**Our Case Number:** ABP-309770-21

**Re:** Proposed development of up to 15 wind turbines with a tip height of up to 175 metres and laying of approximately 26km of underground electricity cabling to facilitate the connection to the national grid, and all associated site development works  
Townlands of Camagh, Carlanstown, Coole, Clonrobert, Clonsura, Doon, Monktown, Mullagh, Newcastle and other townlands, Co. Westmeath

## Submission opposing Planning Application by Coole Wind Farm, Gavin and Jennifer Gallagher

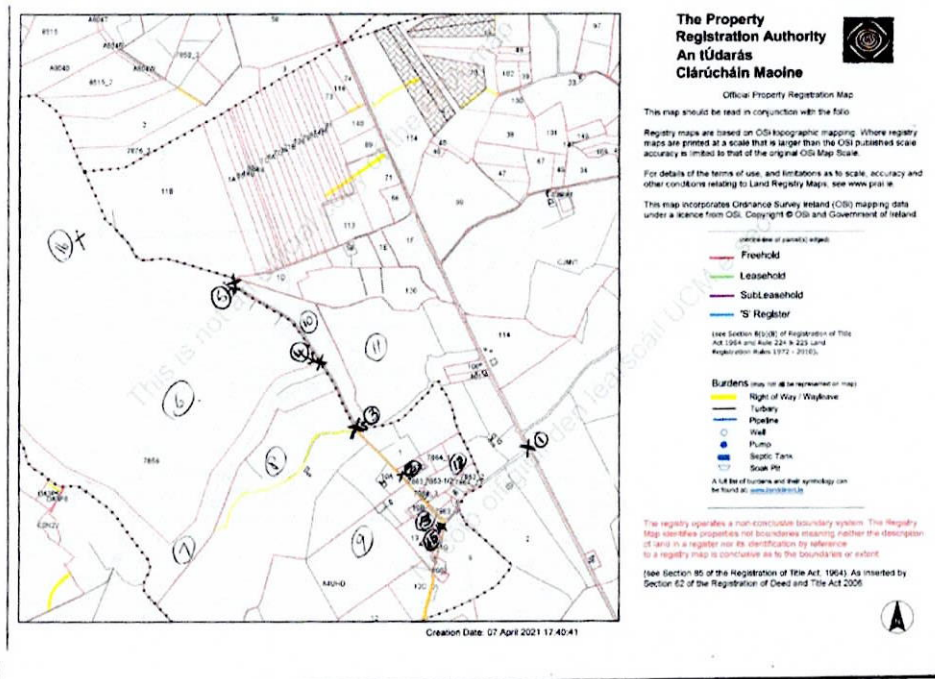
As can be clearly seen from this map the site notice for CWF SID located closest to six proposed turbines (1,2,3,4,5 and 15) has been erected well within private lands, on the edge of private lanes and behind a barrier gate which is a considerable distance from the only entrance onto Clonsura Bog. The only other public access lane has been closed to the public for over 20 years and is completely overgrown with Coillte forestry (behind no.5). We have included photographs of the site notice in situ on page 6 to show how inaccessible this site notice is to the general public. It is possible to drive to the site notice on the privately owned lane, but as it is behind a locked barrier gate, it is only drivable to those who have a key to unlock it: Namely those employed by or contracted to Westland Horticultural Limited, Cavan Peat and now Coole Wind Farm SID. It is only accessible by foot for those who are prepared to walk over 800m on a rough lane to find it, or to those who are prepared to walk a similar distance through brambles, briars, gorse, low branched trees on what was a hard core track from the regional road, but has been overgrown, disused and impassable for decades. This is hardly the correct location for a public notice about a major proposed development. This contravenes planning laws and has denied many people the opportunity to analyse CWF SIDs planning application, send in submissions and involve themselves in the planning process, as they have a right to do. It is against proper planning and development. For this and other reasons CWF SID should be refused planning permission.

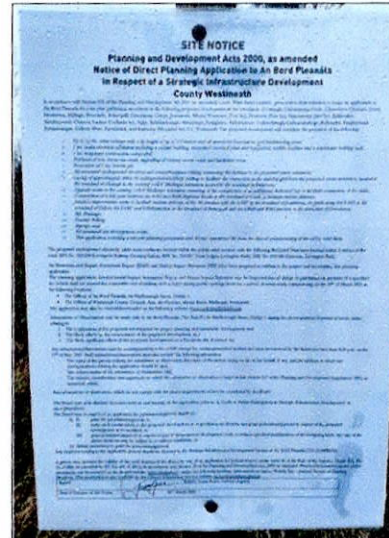
Above and right: The site notice in situ on an A3 size sign and a close up of the information. The information on the signage is very difficult to read.

The left photo shows the impassible overgrown public access lane behind the site notice as indicated. The second photo is of the same lane facing into the bog. The site notice is to the left as indicated.
